Please accept this updated WR V2.0 Summary for NGC's WR regarding the East Pye Project.
This updated summary replaces the WR Summary uploaded as part of Submission S4A7CCF08.
Many thanks.

East Pye Solar Farm EN0110014

**Written Representation Appendices on behalf of
Norfolk Gliding Club**

Map 3 – Station Road Solar Farm

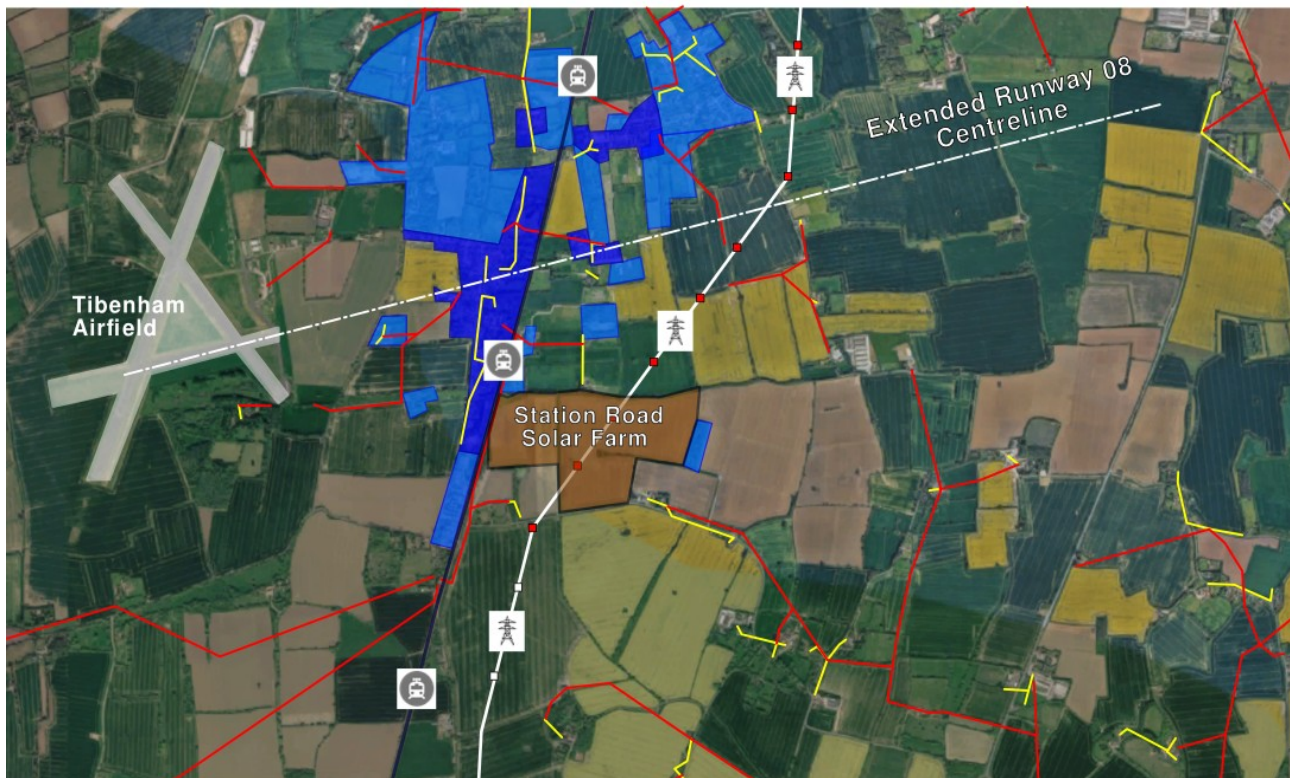
The existence of the UK Networks HV & LV Power Lines has been omitted from the Applicant's 'High Level Investigative Report'.

Map 3 shows the location of the fields that will be taken up by the planned and approved ‘Station Road Solar Farm’. South Norfolk Council previously approved planning consent for this installation - 27th June 2025.

Map 4 – East Pye Proposals

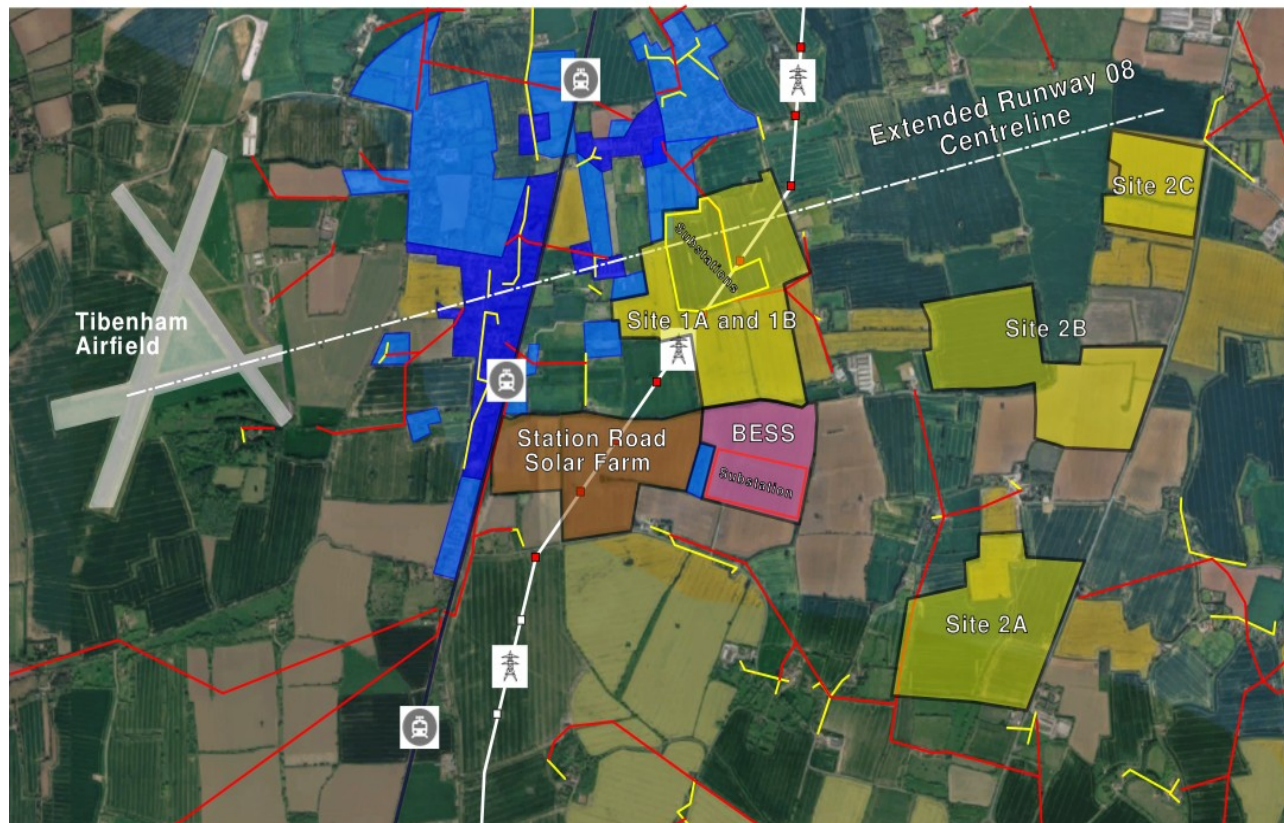
Map 4 shows the same area with the addition of the East Pye proposals: Solar Panels (Sites 1A, 2B, *2), BESS, 2 x East Pye 400kV Substations and 1 x National Grid 400kV Substation.

Although its very likely to affect operations from Tibenham Airfield, NGC have not been provided with any information or consulted on the 400kV Pylon Realignment Project that is required for the National Grid Substation and we are therefore unable to display details of that realignment here and are unable to comment on its impact.

Figure 1: Tibenham Runway 08 – 30° & 45° Take-Off Splays

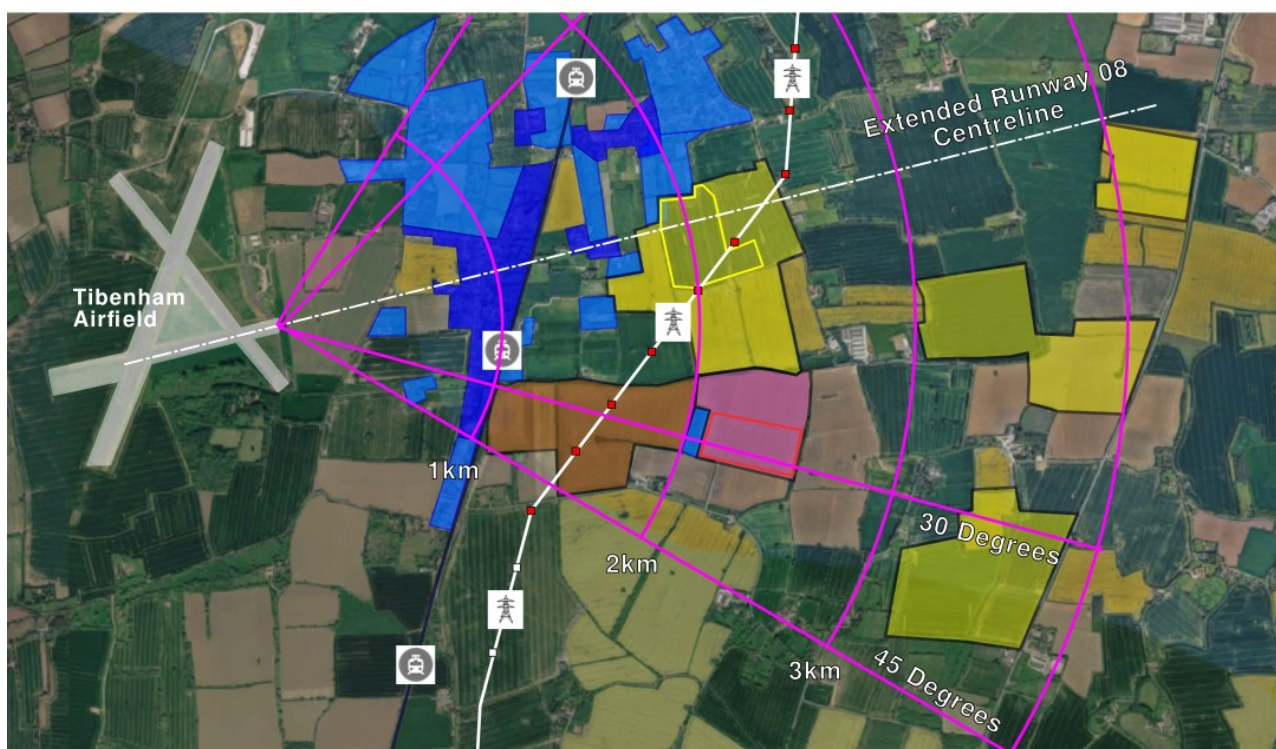
A truer representation of the area around Tibenham, showing the location of the Applicant's proposals including the 'Station Road Solar Farm' installation together with the existing *National Grid Pylons* and *Main Line Railway*, can be seen in the above diagram.

The existence of the '**Station Road Solar Farm**' is shown in Light Brown in the Figure above.

Figure 2: Unsuitable Areas for an emergency off-field landing (Combined)

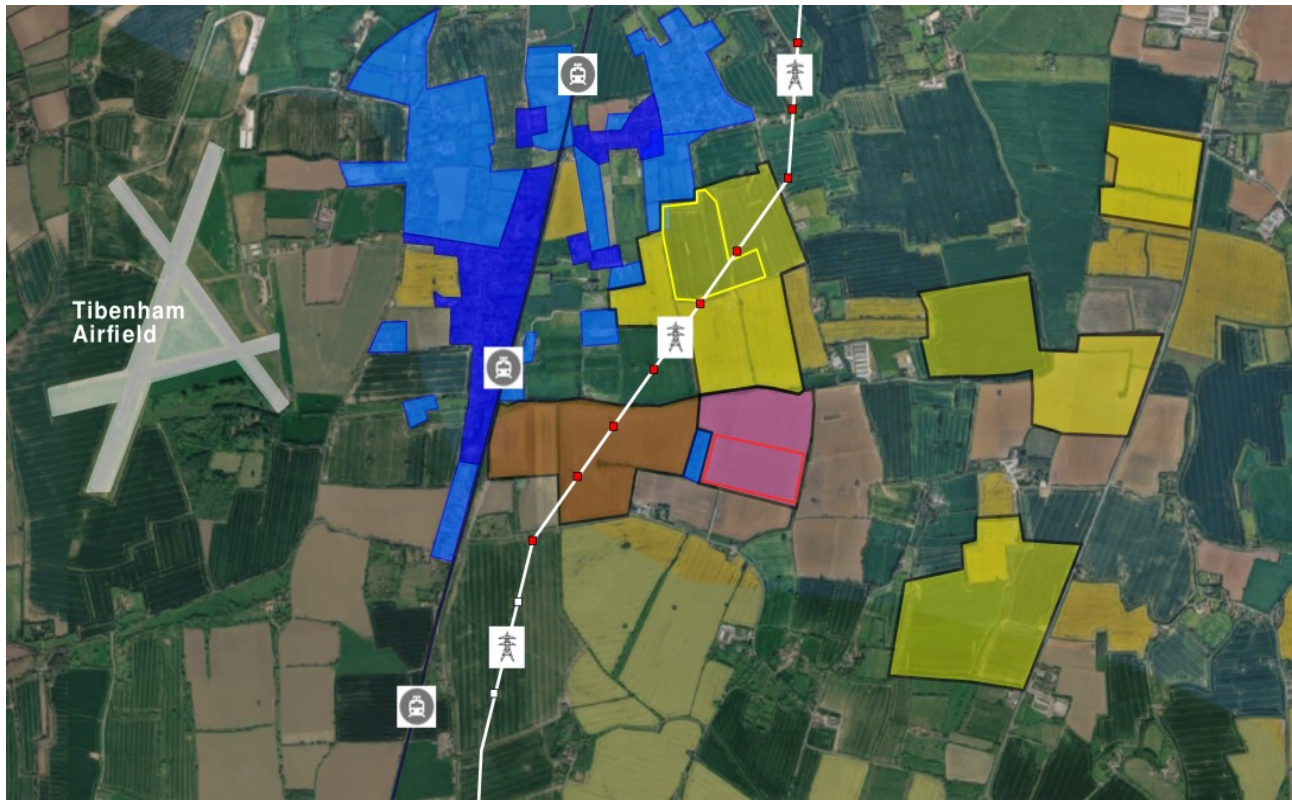
The following figure shows both the areas originally selected within the 'High Level Investigative Report' (Dark Blue – the 30° and 45° areas have been combined) overlaid with those areas selected by NGC (Light Blue).

Detailed maps of those additional areas identified by NGC as being unsuitable for a forced off-field landing are shown in **Appendix C - NGC Unlandables** . Examination of these images will clearly show why these areas have been identified as being unsuitable for an off-field landing.

Figure 3: Calculated 300' EFATO Event

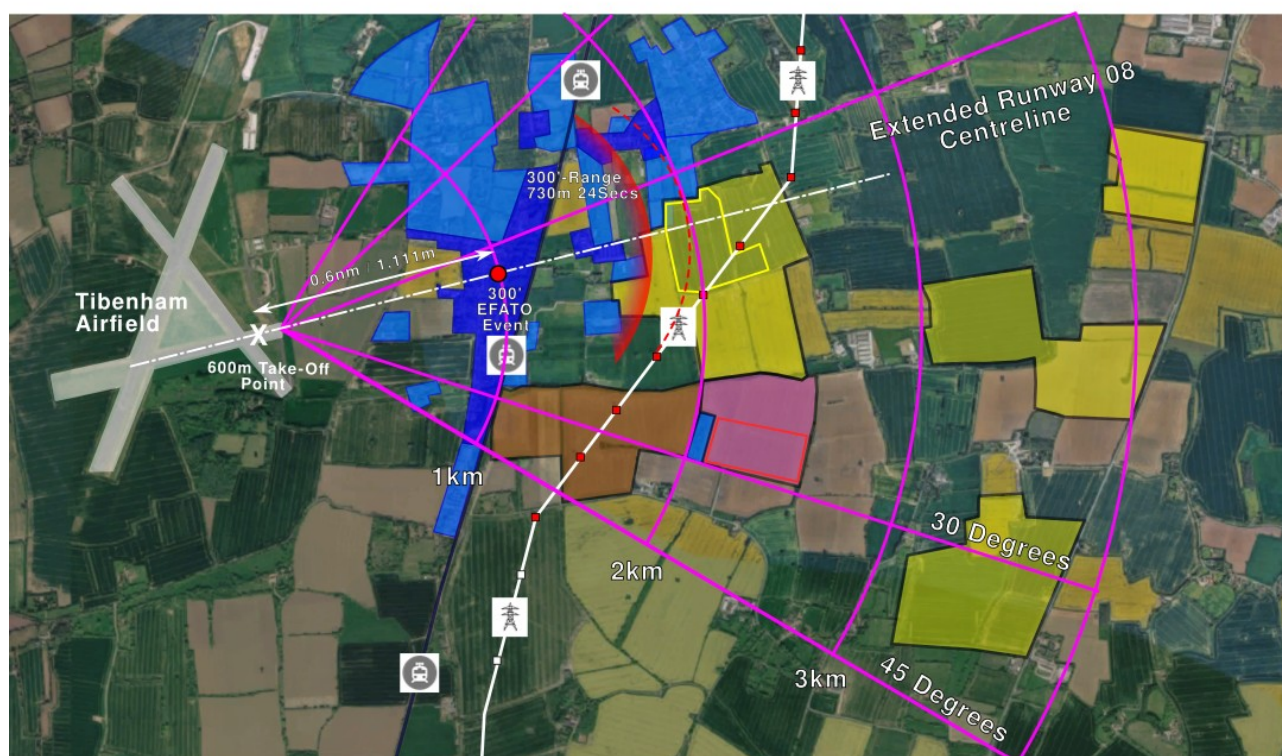
This extended distance is shown in the diagram above as a Red Dotted line located in front of the 45 degree EFATO Range arc and shows the extended reach an aircraft is likely to have following a 300' EFATO event. An estimated 200m extended reach has been assumed, which gives a total distance of 2.04km from the take-off point.

Figure 4: Comparative 300' EFATO Profiles

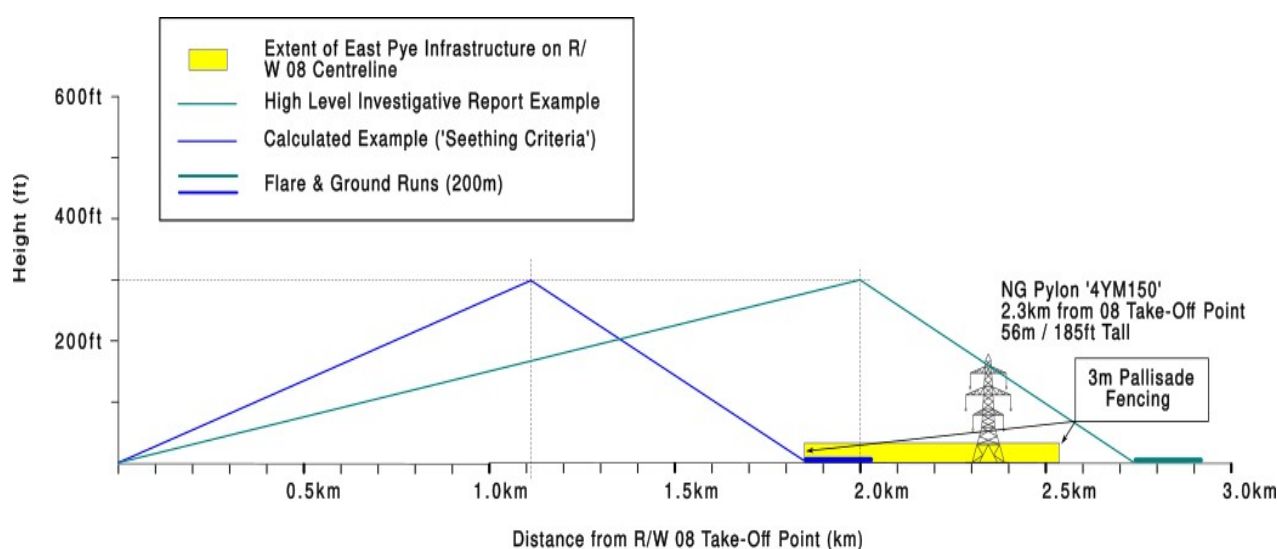
The following diagram shows a profile comparison between the 300ft EFATO example given in the 'High Level Investigative Report' and that calculated using the 'Seething Criteria'.

The narrative around the report's example, incorrectly suggests that heights below the 300ft case do not need to be considered and references an EASA document: '*Easy Access Rules for Air Operations*'. The report then goes on to quote this document as saying: "*It is accepted that performance accountability for engine failure need not be considered until a height of 300 ft is reached*" – See Report Footnote 5.

Figure 4: Map & Profile of a 300ft EFATO Event - Tibenham R/W 08

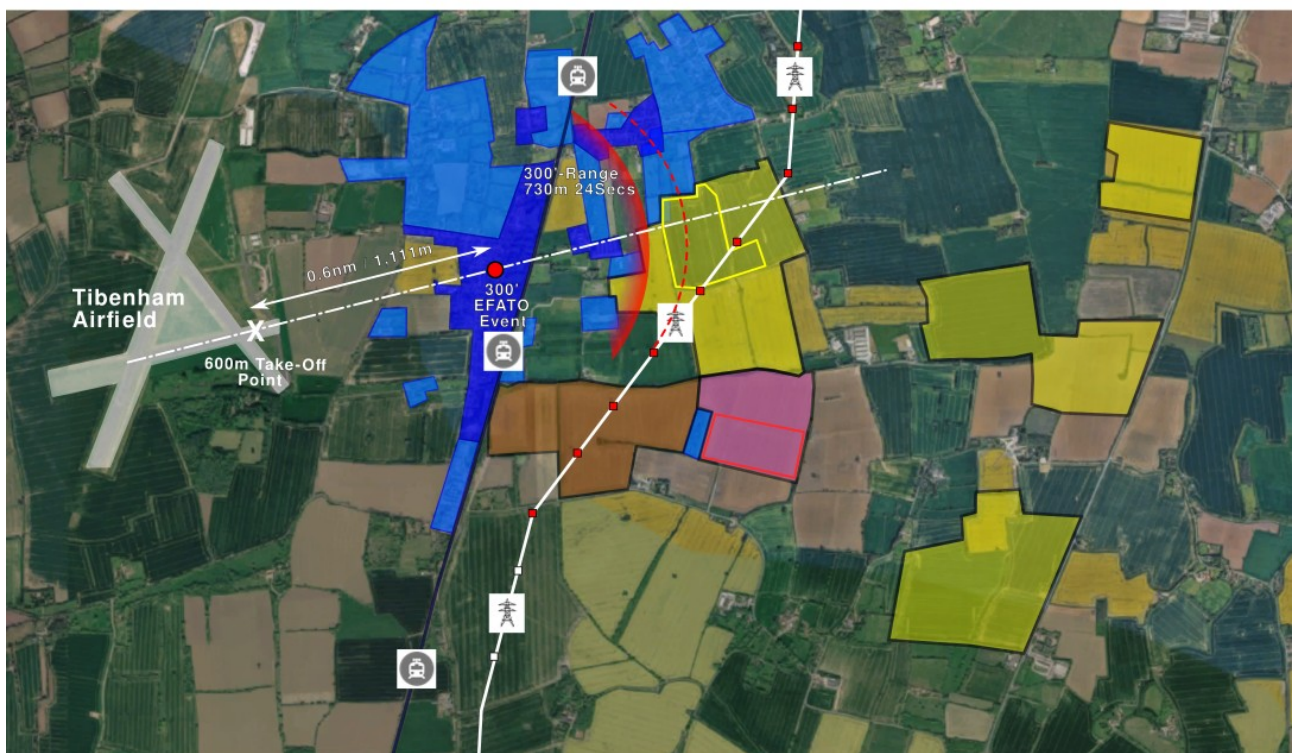
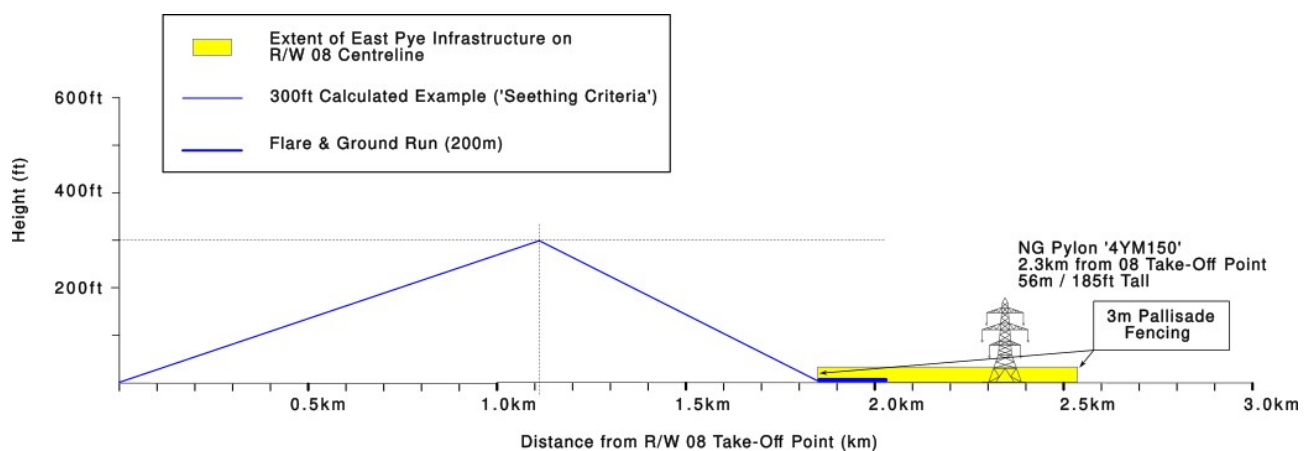
The aircraft would take 1.11km to reach 300ft, with a downslope distance of an additional 730m, plus an additional 200m for the 'Flare' and 'Ground Run' – totalling 2.04km and would reach the extent of the Applicant's proposed energy installations.

The pilot of an aircraft suffering an EFATO on departure from runway 08 at 300ft would have their forced off-airfield landout options severely constrained by the Applicant's proposed energy installations and experience a markedly reduced choice of options for a forced off-airfield landing.

Figure 5: Map & Profile of a 400ft EFATO Event - Tibenham R/W 08

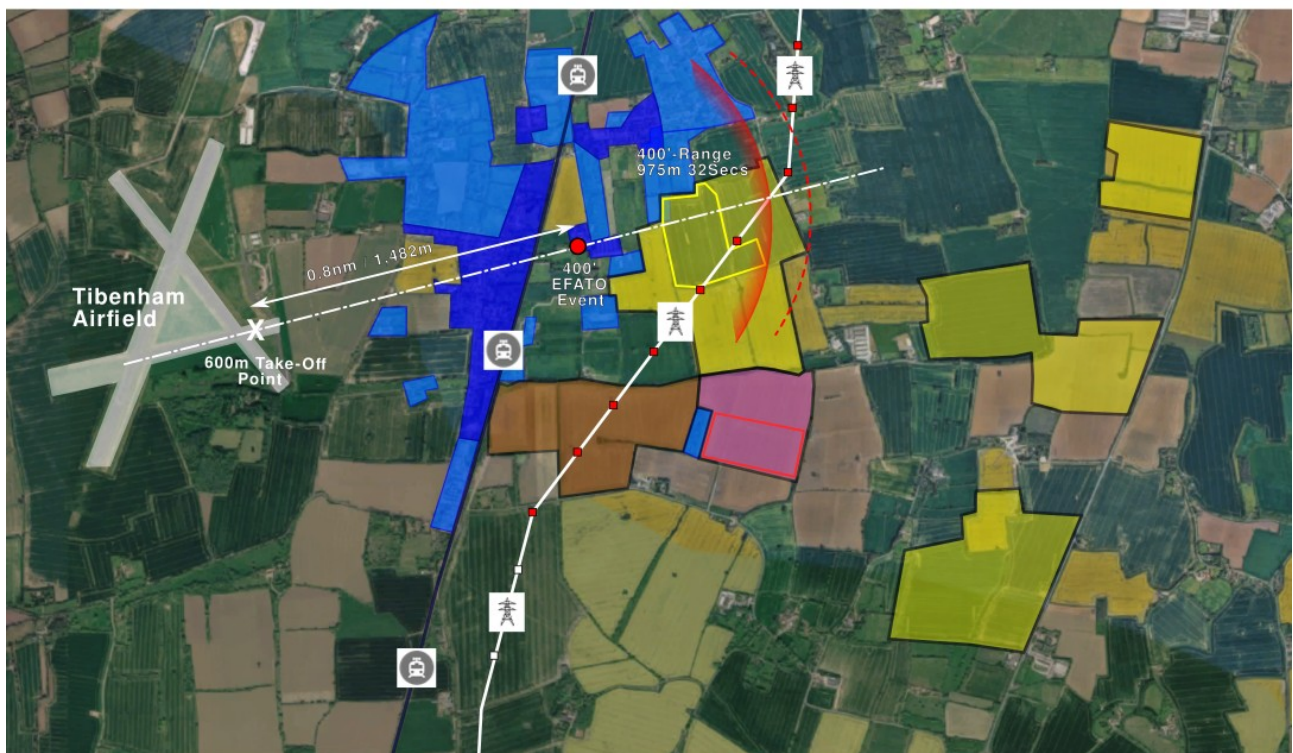
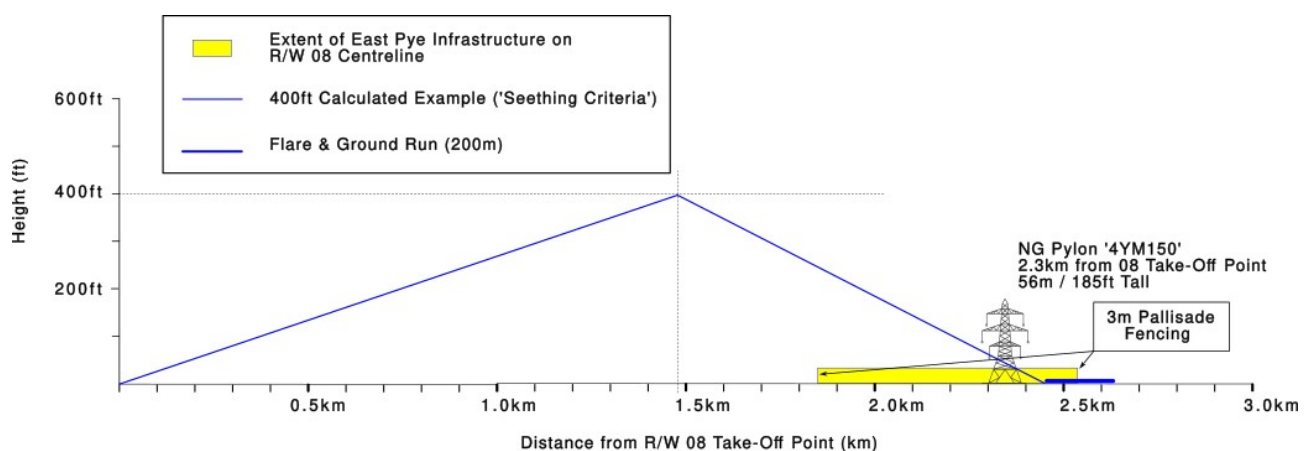
The aircraft would take 1.48km to reach 400ft, with a downslope distance of an additional 975m, plus an additional 200m for the 'Flare' and 'Ground Run' – totalling 2.66km and would reach the extent of the Applicant's proposed energy installations.

The pilot of an aircraft suffering an EFATO on departure from runway 08 at 400ft would have their forced off-airfield landout options severely constrained by the Applicant's proposed energy installations and experience a markedly reduced choice of options for a forced off-airfield landing.

Figure 1: Map1 - Before East Pye

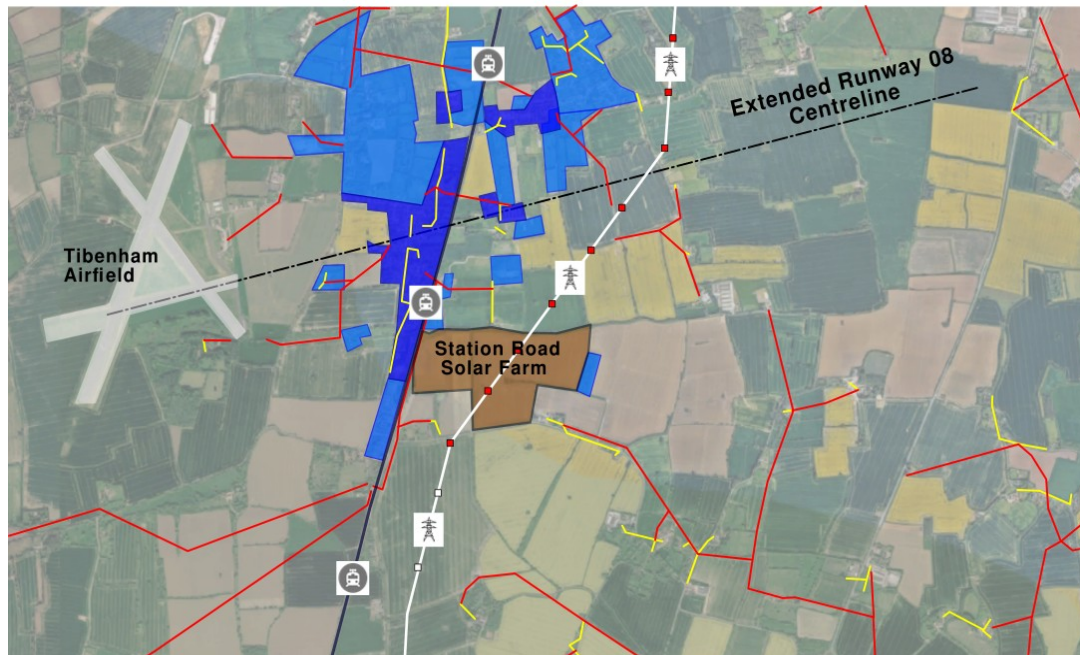
NGC has produced a series of maps (summarised here) showing the extent of current and planned energy infrastructure projects in the vicinity of Tibenham airfield and comparing them to show how the Applicant's proposed Solar infrastructure will severely restrict options for a forced off airfield landing
